Meeting Agenda

Historic Zoning Commission

Monday, February 10, 2025

REMOVAL OF HVAC
EQUIPMENT AND SCREENING

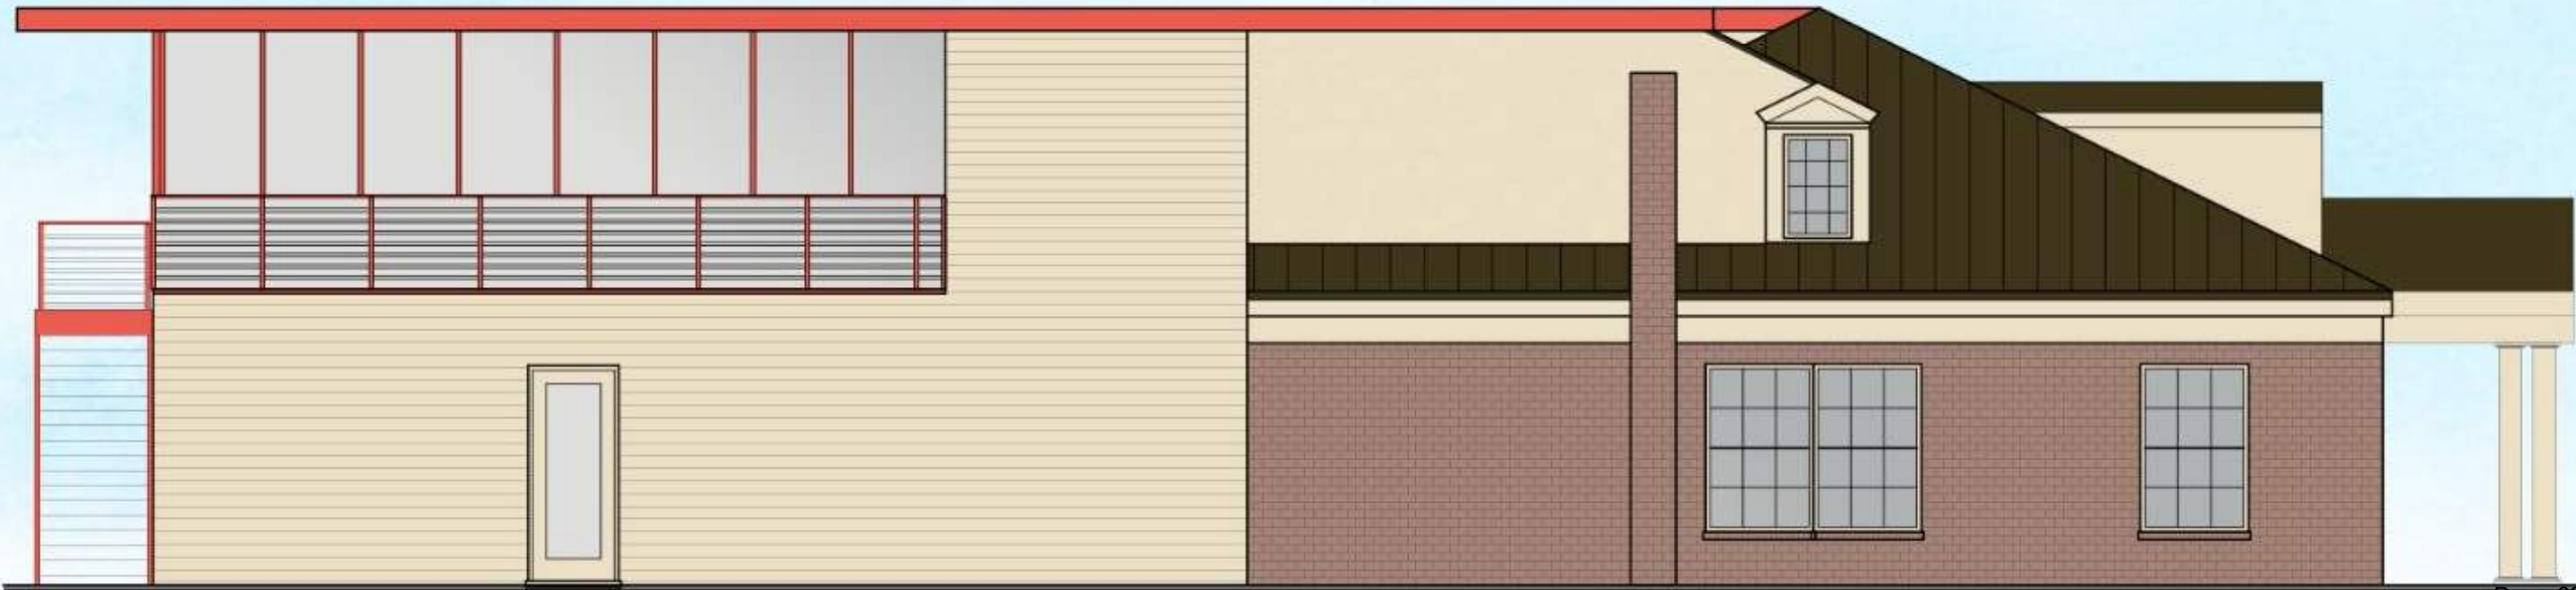
The existing HVAC equipment, walk-in cooler, and wooden screening are seen on the West and North elevations (front and left sides) of the building. It is proposed to remove this equipment and generally clean up the site. These changes are supported by the Guidelines.

① SITE PLAN
3/16" = 1'-0"

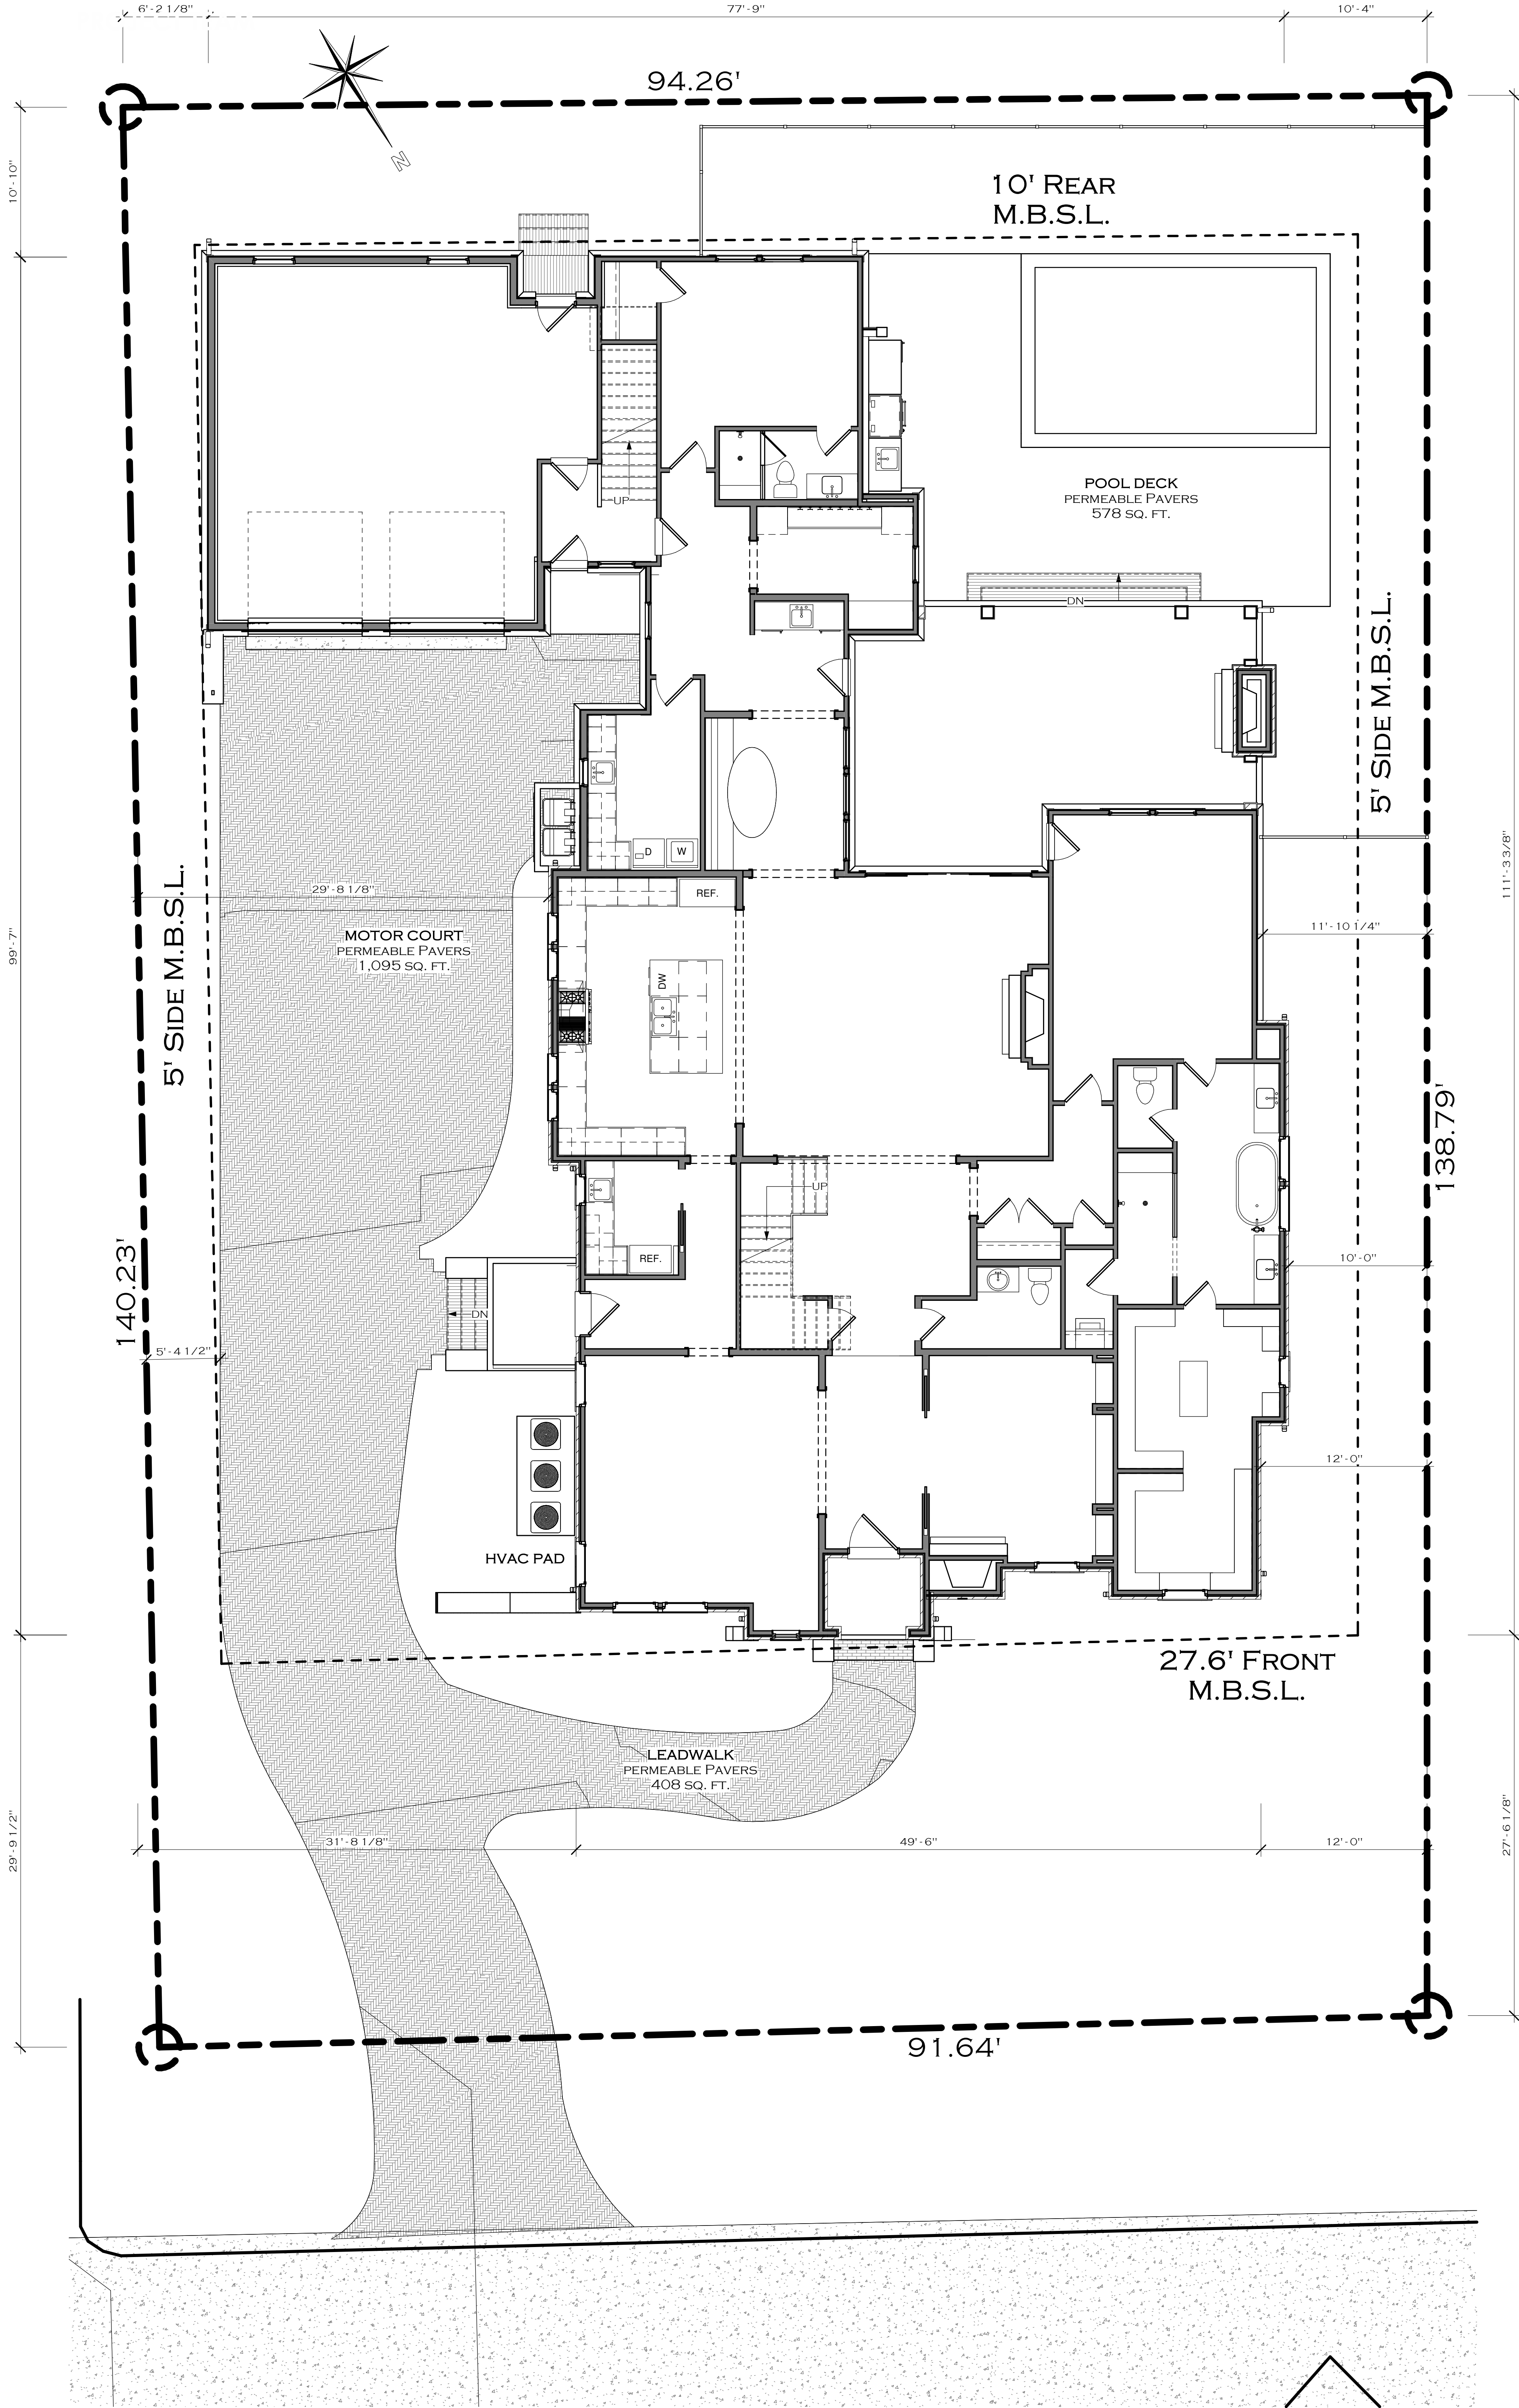
A curving walkway and driveway are proposed on the site. The driveway, while curving, does not cross the plane of the front façade of the building. The apron of the driveway does appear to partially located in front of the building. The material of the walkway and driveway is proposed to be a permeable pavers. Per the Zoning Ordinance the minimum Landscape Surface Area for the R4 Zoning is 40%.

The data and calculations will need to be revised to show the accurate LSA requirement.

6. The driveway must be straightened, if the topography allows, to follow a more traditional pattern for driveways.
7. The site data shall be revised to show the R4 Zoning District Landscape Surface Area ratio requirement as 40%.
